## **AGENDA**

President and Board of Trustees  
Village of Arlington Heights  
Board Room

Arlington Heights Village Hall  
33 S. Arlington Heights Road  
Arlington Heights, IL 60005  
October 16, 2017  
8:00 PM

**KLOA**  
Kenig, Lindgren, O'Hara, Aboona, Inc.  
Job No: 17-127 Figure: 5

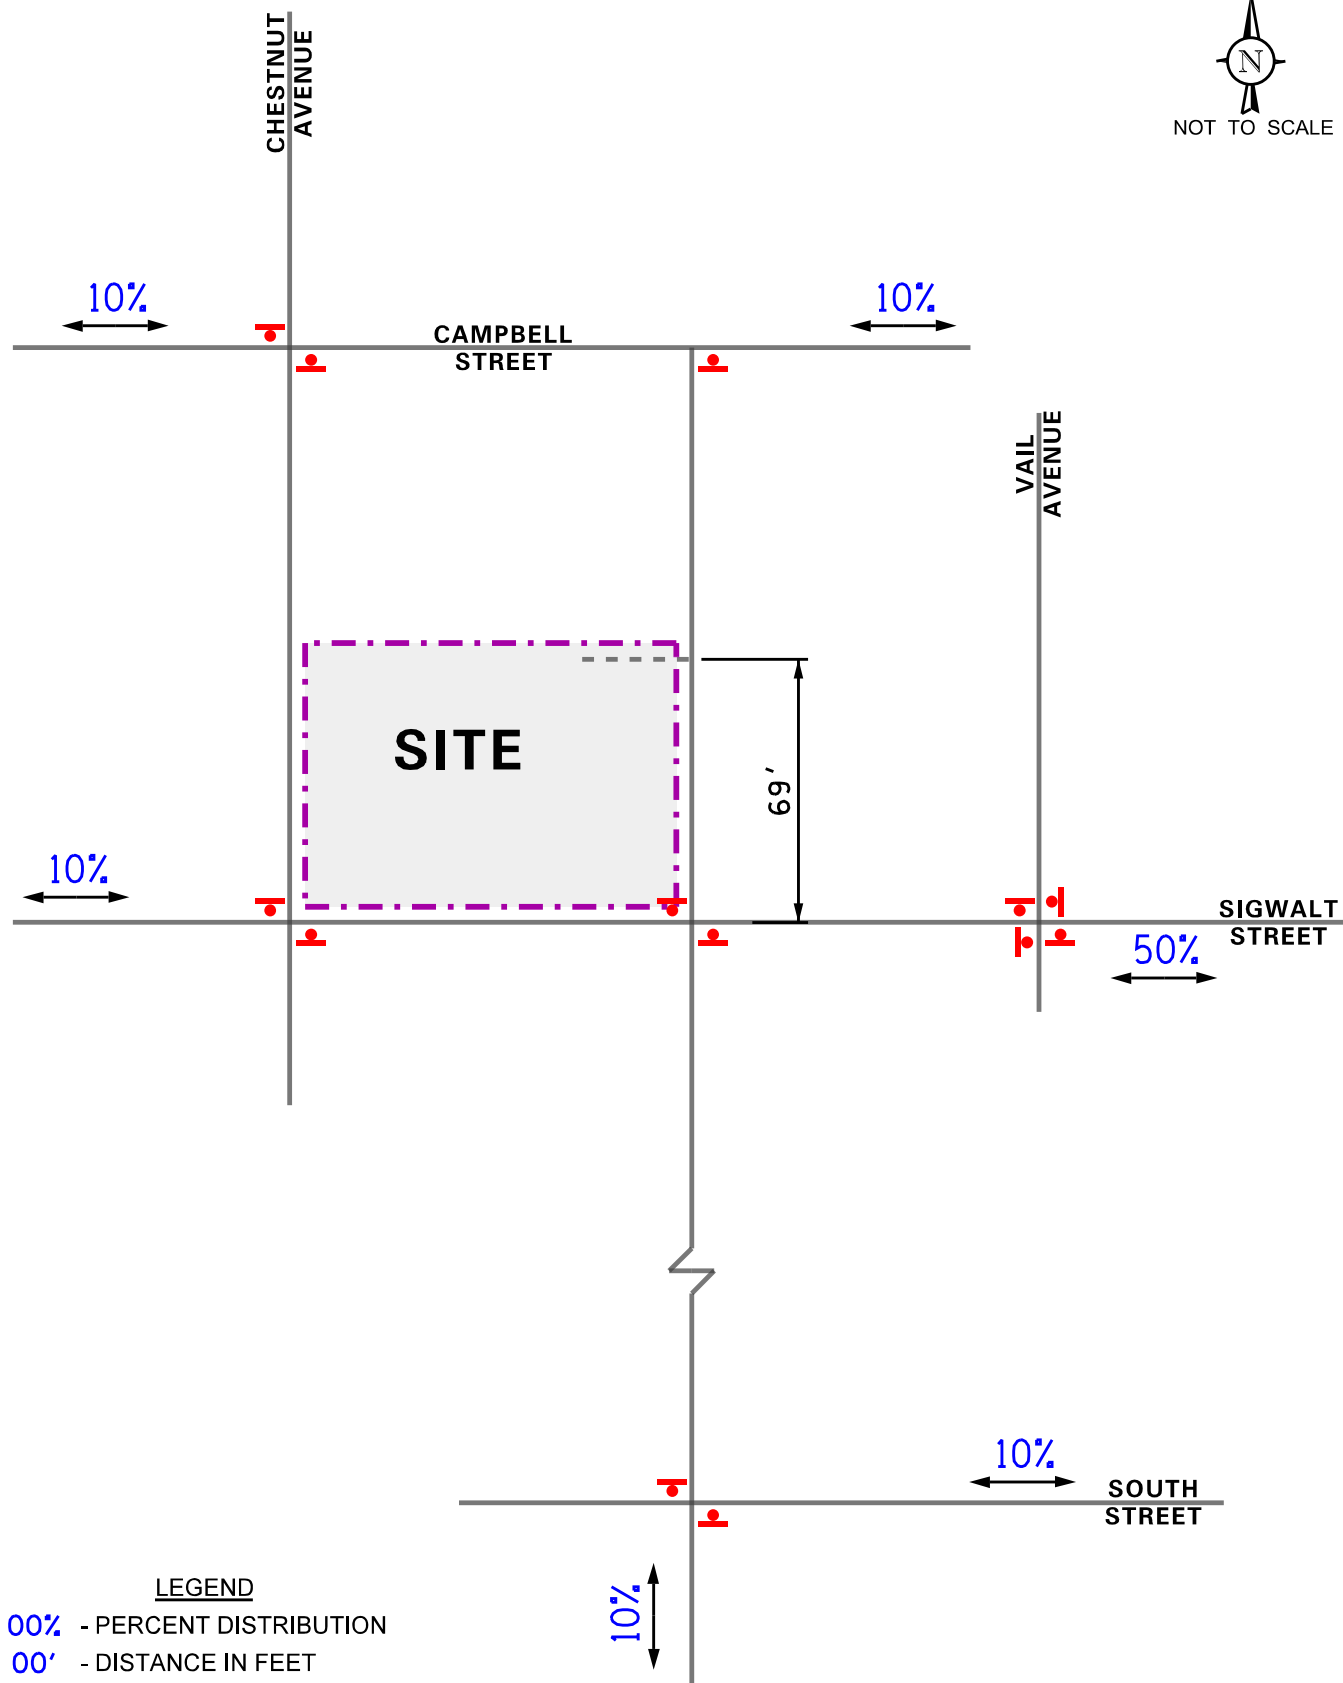
- 22. The representation of site traffic distribution seems incorrect as only 10% of site traffic is proposed from the north. The Traffic data reflected in Figures 4, 5, 6, and 7 should be modified to show the peak hour traffic counts for the intersections of Campbell and Chestnut.**

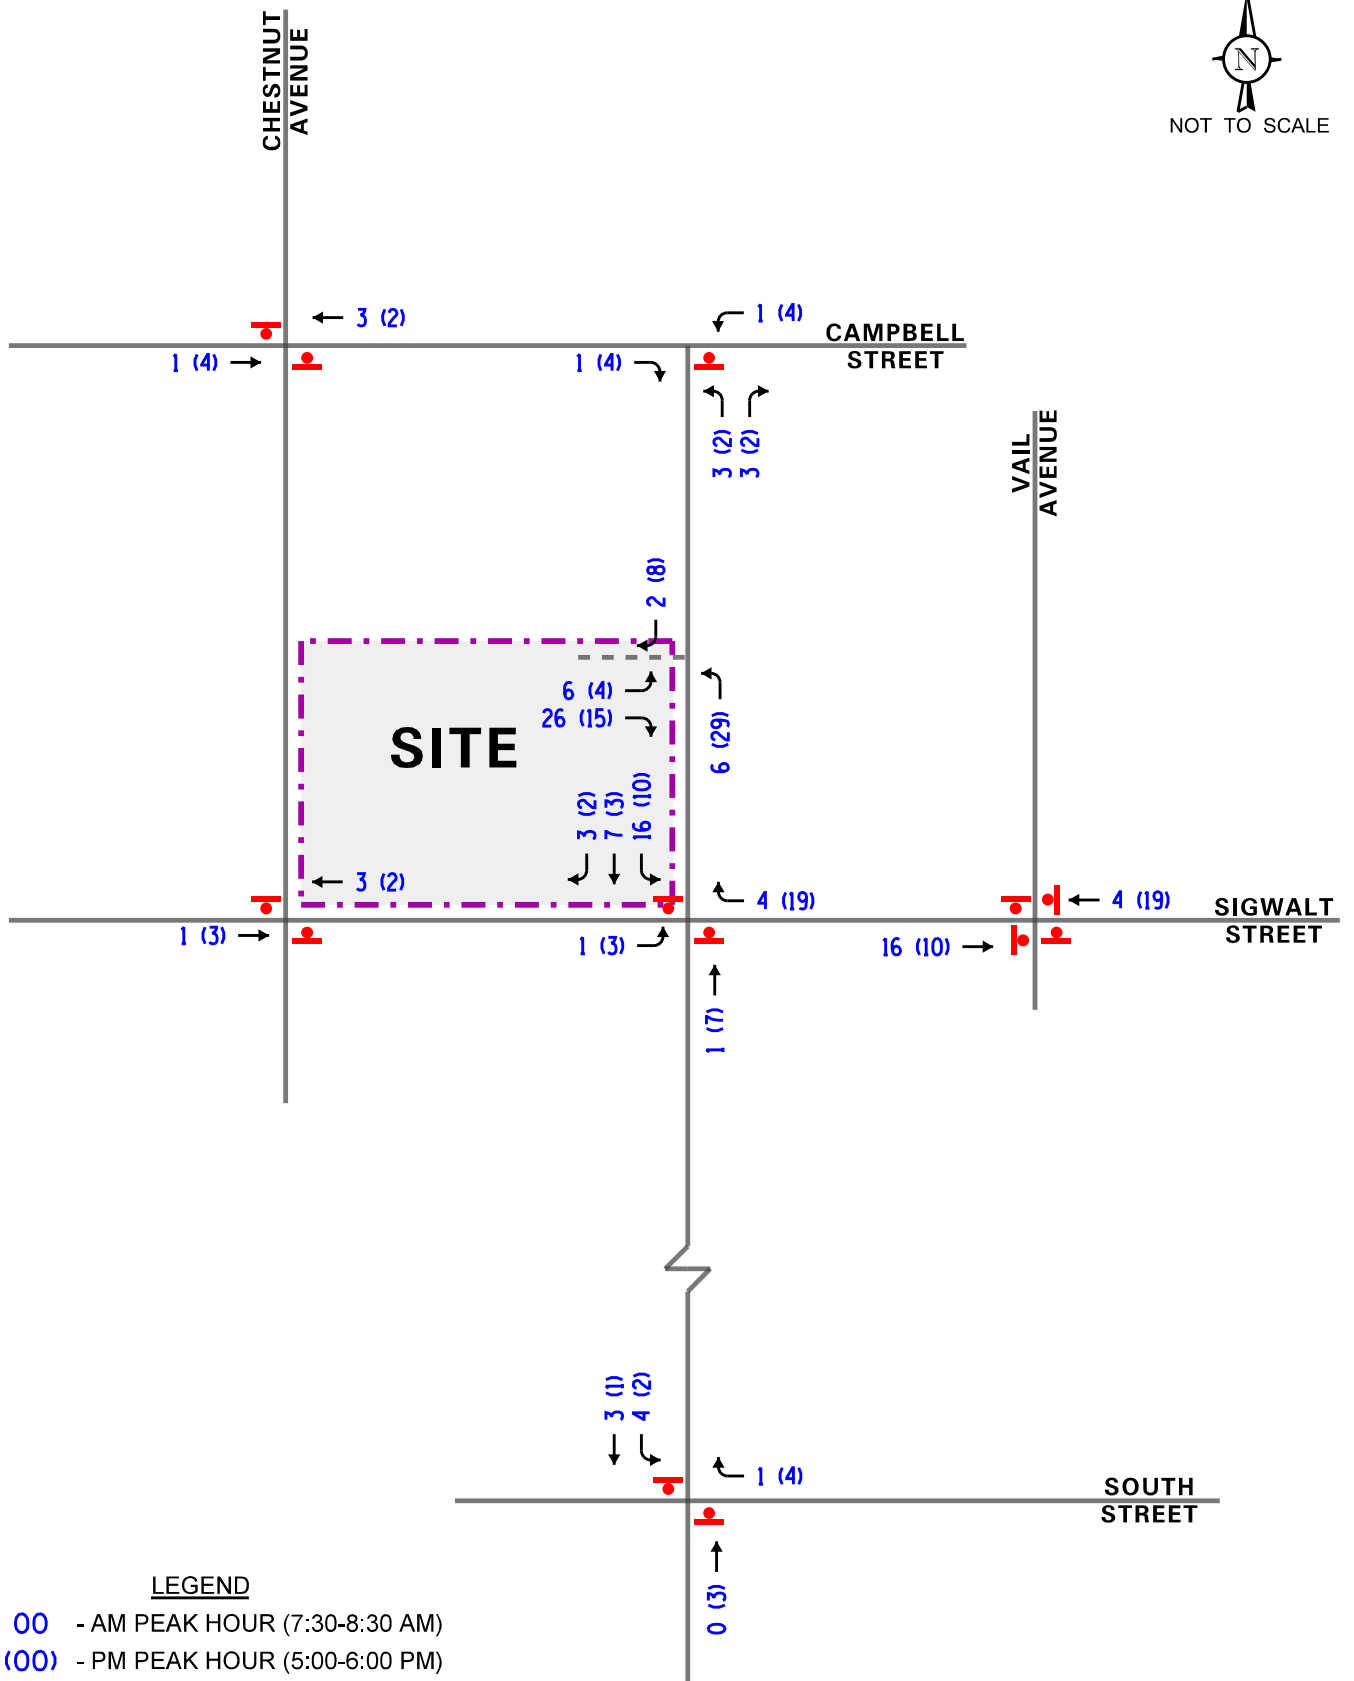
29. The response made by the petitioner to comment #22 is not acceptable. Although the site generated traffic has included the additional intersections requested, the values shown on Figure 6 do not sum correctly through the intersection of Sigwalt and Highland for the site generated traffic.
